**CITY OF SNELLVILLE
PLANNING & DEVELOPMENT DEPARTMENT
BOARD OF APPEALS**

VARIANCE CASE SUMMARY

CASE NUMBER: #BOA 20-01

DEVELOPMENT/PROJECT: 161-Lot, 20.15± Acre Cooper Springs
Townhome Development

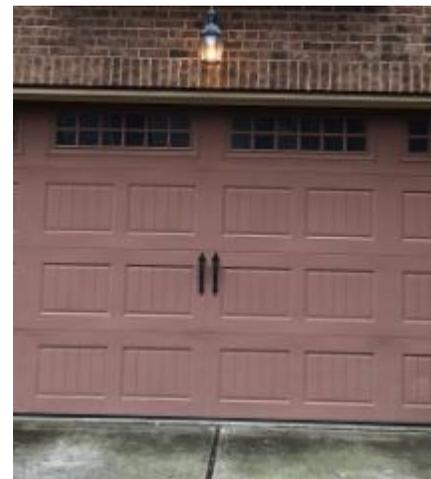
The applicant contends that this requirement is essentially impossible to comply with for a single-family detached product as the townhome units are twenty-four (24) feet wide and include garages and driveways. Requiring a seventy-two (72) square foot covered porch would require the porch to be built all the way out to the curb on top of the sidewalk. While this may make sense in some single-family detached application, it makes no sense in the context of a 24-foot wide townhome community.

Instead, the applicant intends to build covered porches that will be roughly 5'-8" wide by 6' deep, or roughly thirty-four (34) square feet in size.

The deeper and larger porch requirement is much easier to accomplish in a single-family detached subdivision where the lots are deeper rather than a townhome community. Although no formal variance approval records can be found that granted relief to the original developer/builder for the thirteen (13) existing townhome units constructed in early 2007 that do not have the required front porch parameters, it can be assumed the requirement was never mandated by the city.

This request is recommended for approval.

- **Approval** of the variance to allow the front porch depth to be less than six (6) feet deep and allow the front porch size to be less than seventy-two (72) sq. ft. in area;
- **Approval** of the variance to allow use of a coach-style light fixture above each garage in lieu of requiring the use a front yard light fixture placed one-foot outside of the right-of-way.
